## Sevenoaks 20mph Questions – Cllr Rakes and Cllr Bonin

Questions and comments from Cllr Bonin:

Figure 1: Video survey showing pedestrian surveys

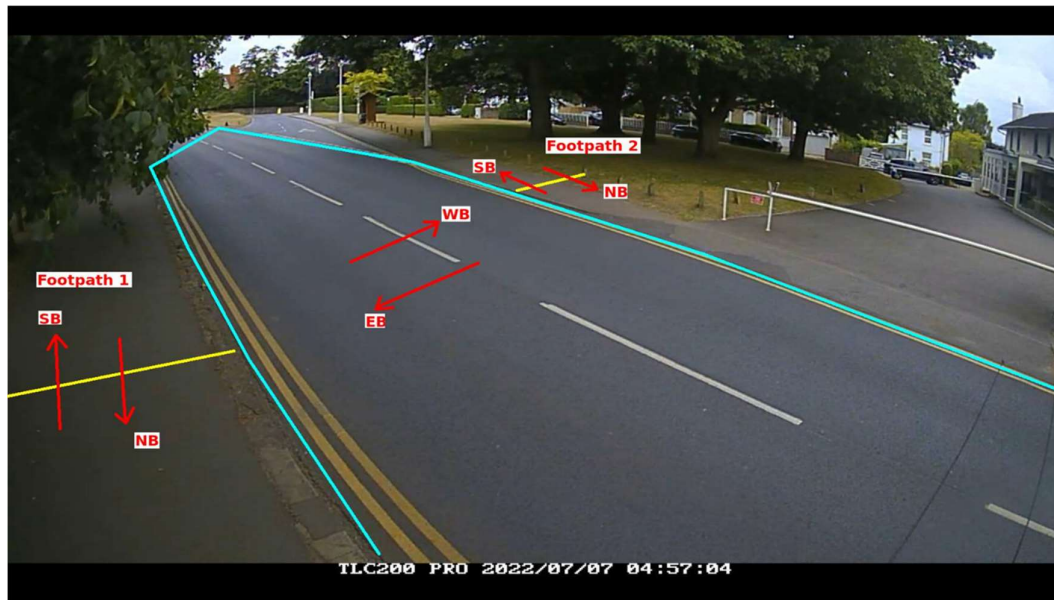
4. Is there an estimate of how many people will use the new zebra crossing on an average day?

**Traffic and pedestrian surveys were conducted at the location of the xing on 7<sup>th</sup> July 2022. Below Table shows the actual number of pedestrians crossing the road. During the AM Peak of 0800-0900 (24 times) and PM Peak of (26 times). NMU means non-motorised users**

It needs to be pointed out that in the two peak periods the total number of pedestrians using the footways was **136 (AM Peak)** and **98 (PM Peak)**. The proposed crossing will result in more use of by these pedestrians. See image below showing the points surveyed.

Figure 2 Cross-section of cyclist and two passing hgvs

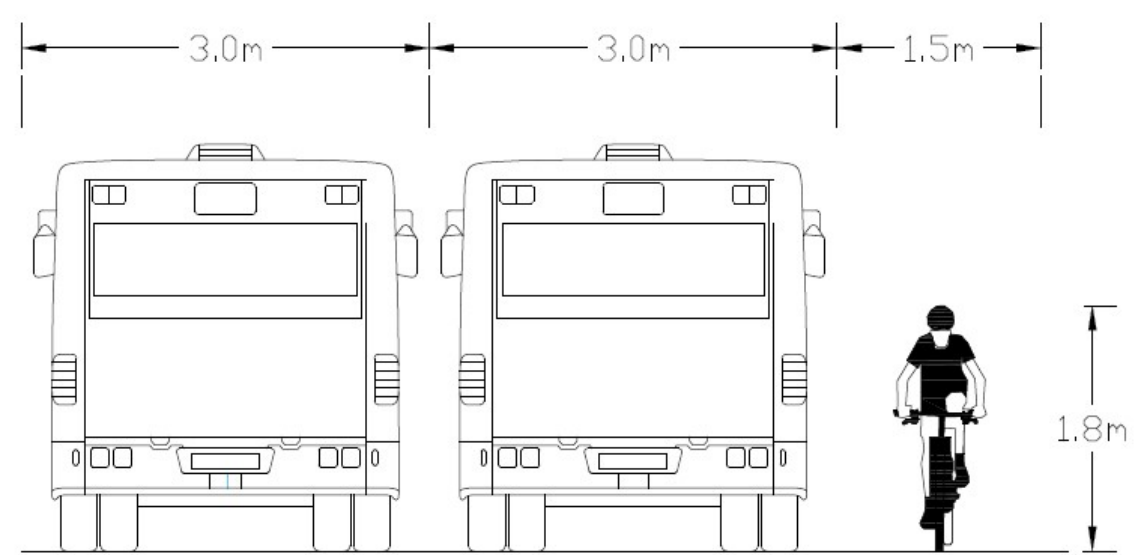
5. The section of Dartford Road to the south of the one-way system will become very narrow through the addition of the cycle lane. During busy times cars form a southward bound queue along this section of road. Will large vehicles heading northbound be able to navigate this section of Dartford Road without having to mount the pavement or cause a traffic blockage? What are the current number of vehicle and HGV movements northbound during peak time?

The width of the traffic lanes will be maintained at 3.0m. The above traffic survey includes the volume of HGVs using Dartford Road by direction. The daily volume of HGVs heading north and south on Dartford Road is shown in the table 2 below.

In addition, the width of the carriageway was measured at 7.5m typically along this section of Dartford Road. The width of the worst-case hgvs is typically 2.55m worst-case and including wing mirrors will increase to 2.8m, the below cross-section will highlight the space for cyclists. Figure 2 below shows a typical cross-section.
